Replacement of Hydromassage Jet Insert

Models: Hot Spring, Tiger River, Solana

This instruction outlines the procedure for replacing the hydromassage jet head used in the Hot Spring, Tiger River, and Solana spas.

Figure 1: Obsolete Jet Heads with Jet Face

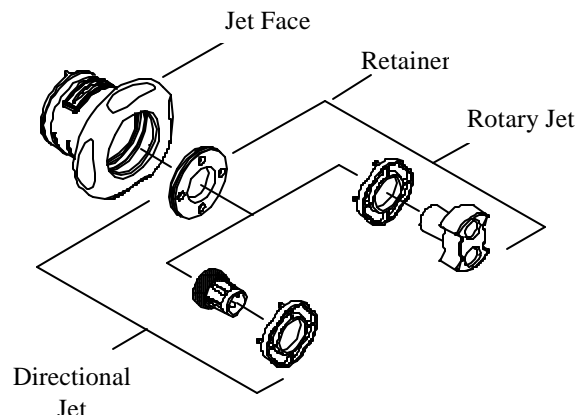
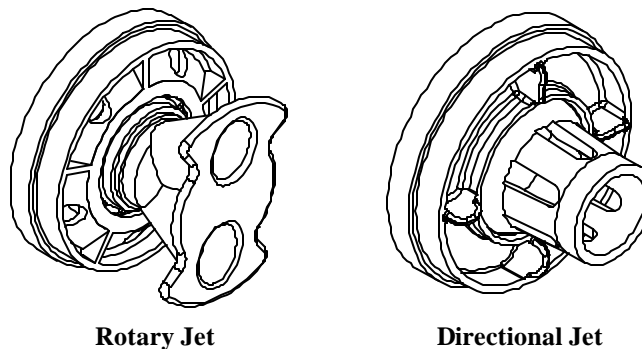
Reason for upgrade: Changes have been made to improve the structure and design of the rotary and directional hydromassage jet. The replacement threaded jet inserts are mounted as single pieces instead of the original 3 separate pieces for greater durability.
